ADMINISTRATIVE DETERMINATION & CERTIFICATION

FINAL PLAT

Walnut Addition, PF-16-00247

PF-16-00247: Final Plat for Walnut Addition, a 7 lot subdivision located 775 Walnut Street. Submitted by Grob Engineering Services LLC, for Lawrence Habitat for Humanity, property owner of record.

Figure 1. Utility and drainage easements highlighted yellow = easements shown on Preliminary Plat
blue = easements proposed with Final Plat)

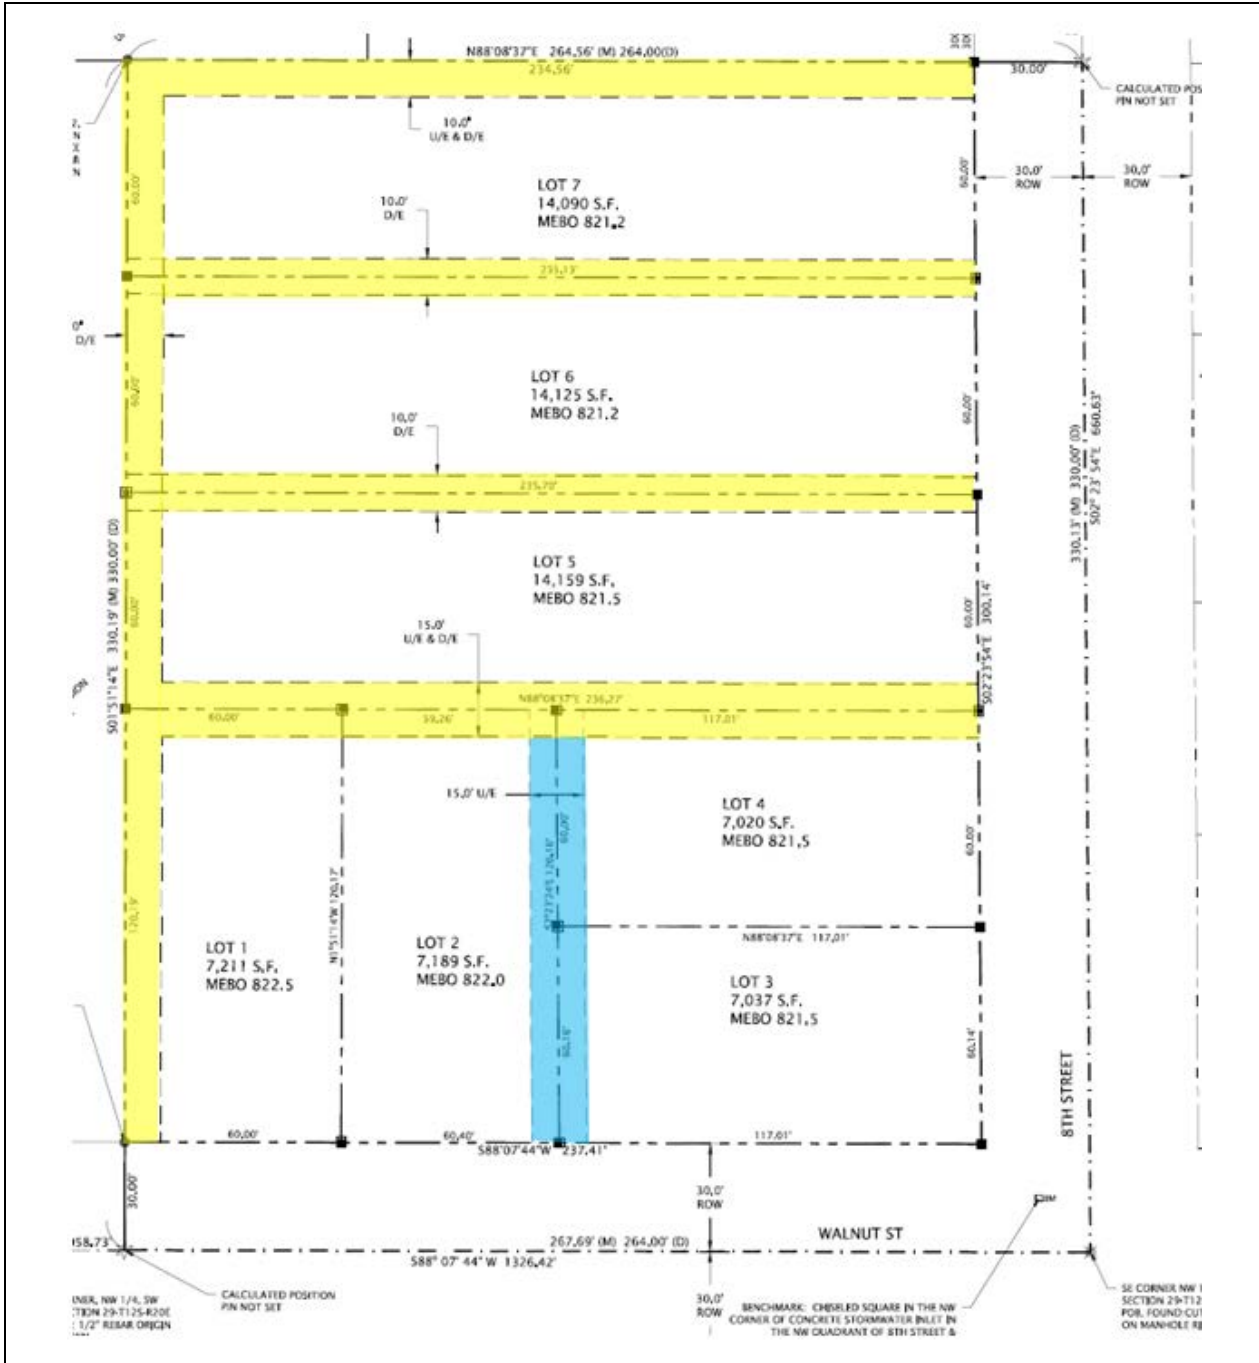
The Final Plat contains the same dedications as the Preliminary Plat with the addition of a utility easement along the east lot line of Lot 2 and the west lot line of Lots 3 and 4. Acknowledgement of dedications as shown on the final plat is scheduled to be heard by the governing body and is an action required for approval.

The utility and drainage easements shown on the Preliminary Plat are also provided on the Final Plat. The Final Plat adds a 15' utility easement along the east lot line of Lot 2 and the west lot line of Lots 3 and 4 (Figure 1).
